CONTRACT ADDENDUM

Contract Addendum No.: One (1)

Addendum Date: 8/6/2021

**ASHLAND MUNICIPAL COMPLEX BUILDING
TOWN OF ASHLAND, MISSISSIPPI**

SHEET NO.
C-2.0

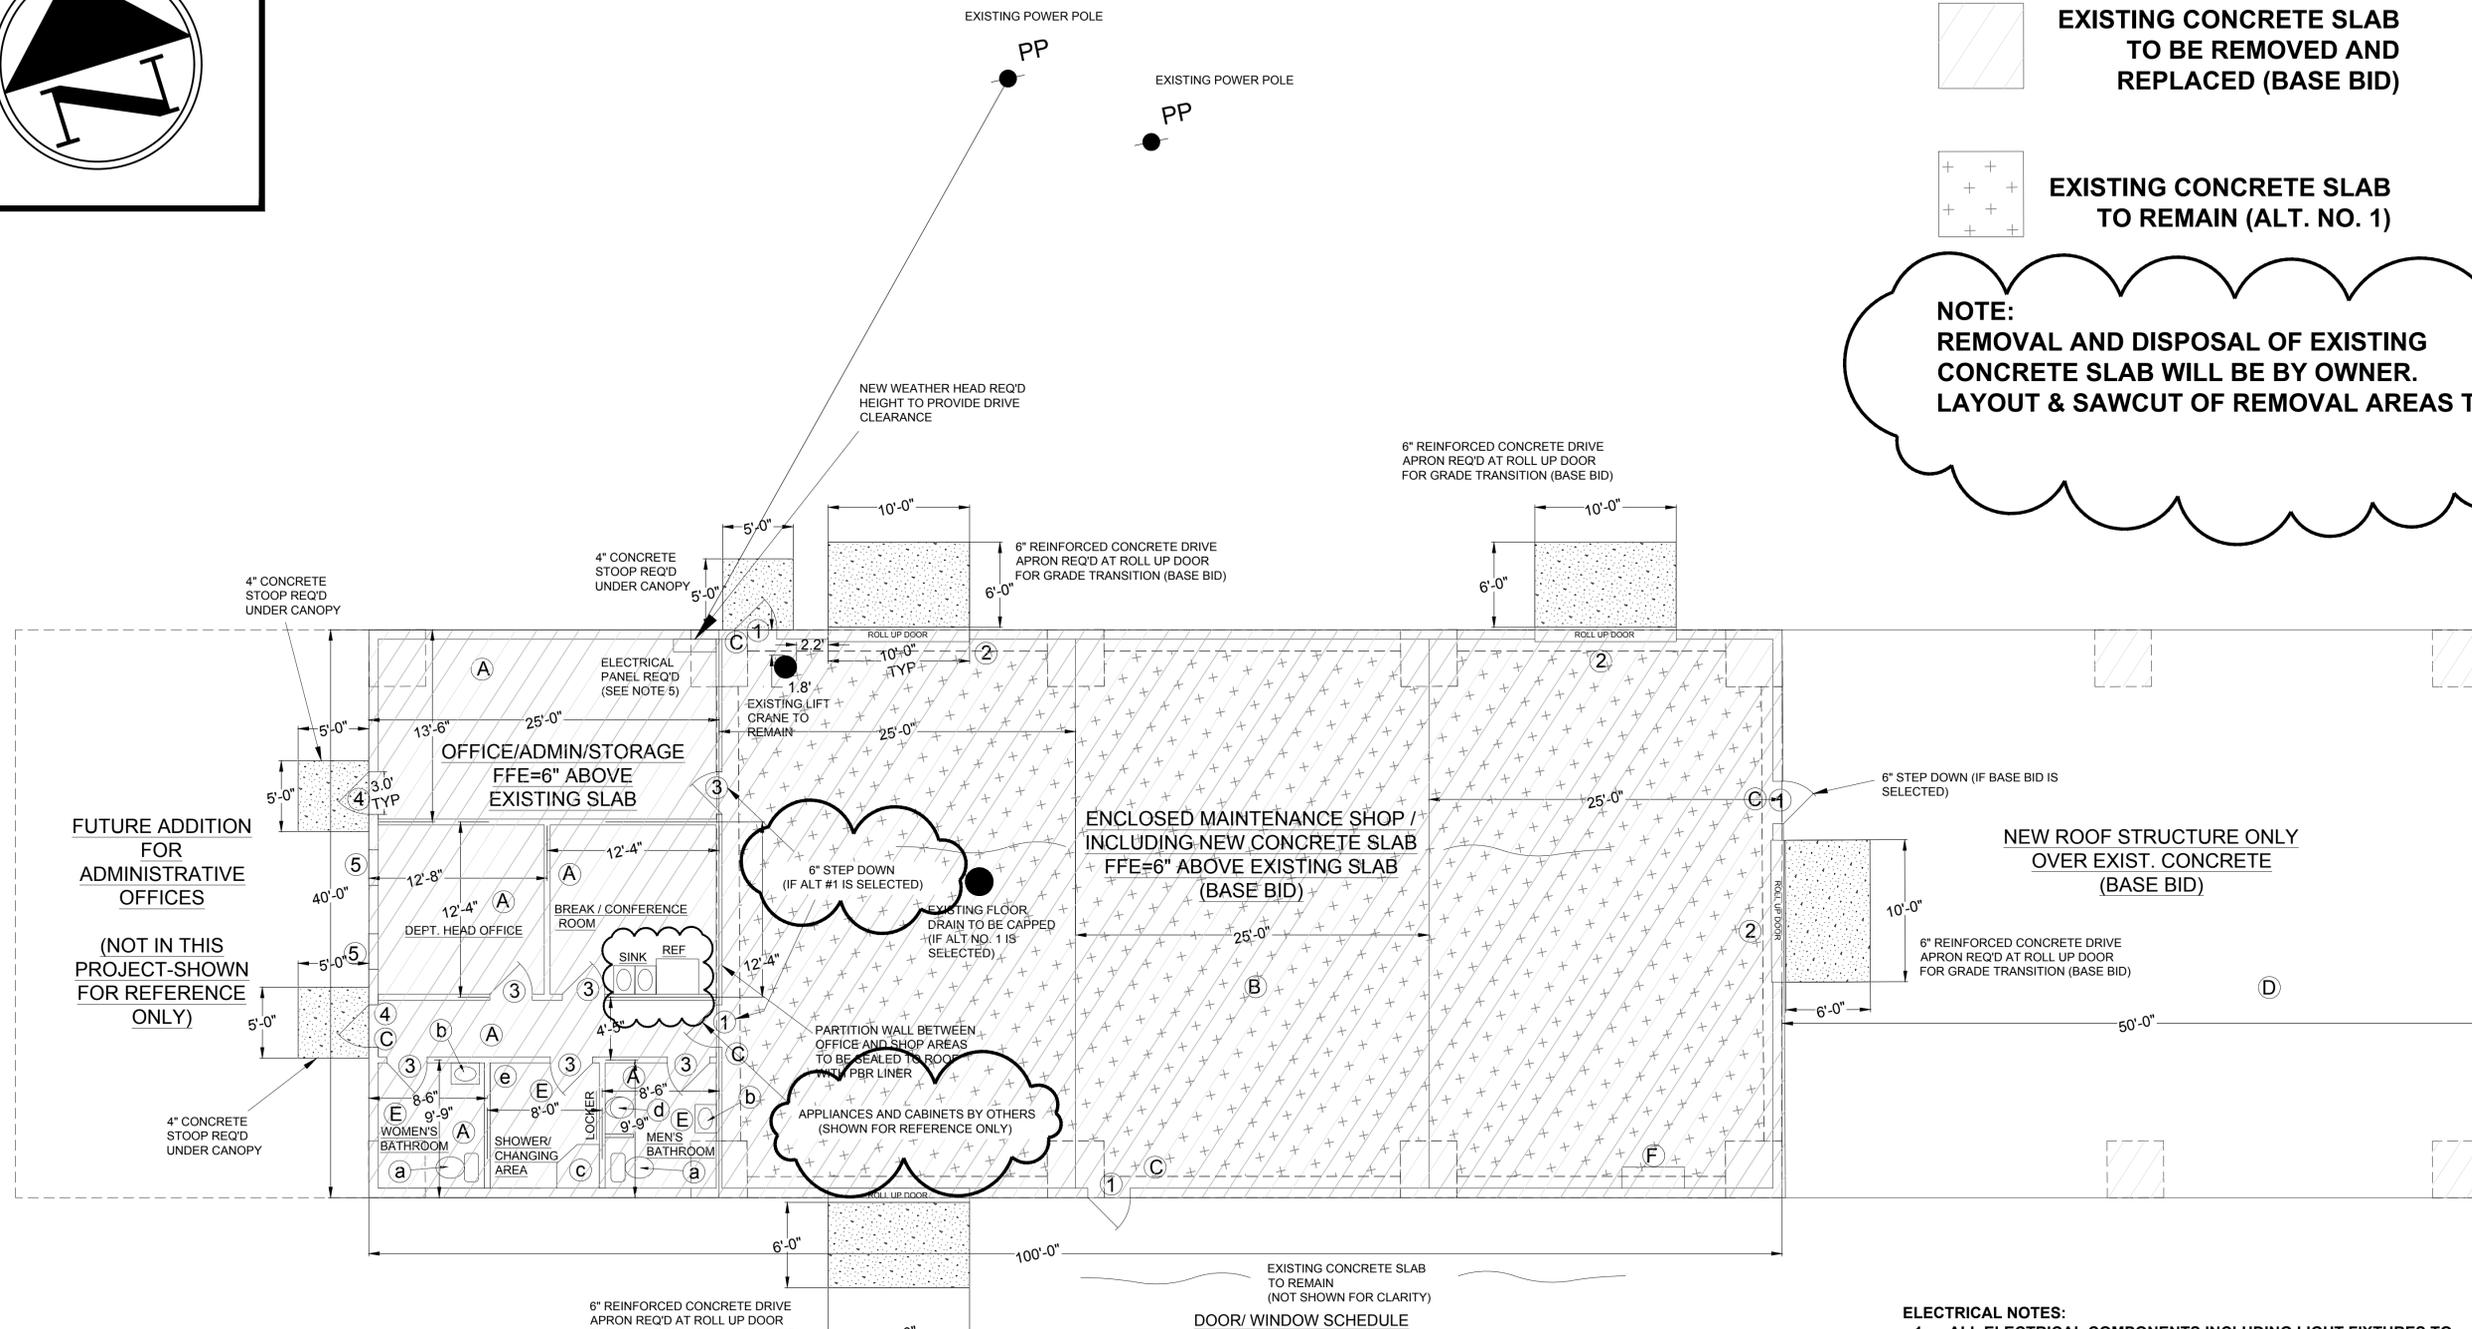
1. Drawing C-2.0 PLAN VIEW , REV. IFB 07-06-21 – **Replace** in its entirety with **Attachment No. 1 to Addendum No. 1.** (Drawing C-2.0 PLAN VIEW, REV. IFB 08-06-21).
2. Drawing C-3.0 ELEVATION VIEW, REV. IFB 07-06-21 – **Replace** in its entirety with **Attachment No. 2 to Addendum No. 1.** (Drawing C-3.0 ELEVATION VIEW, REV. IFB 08-06-21).
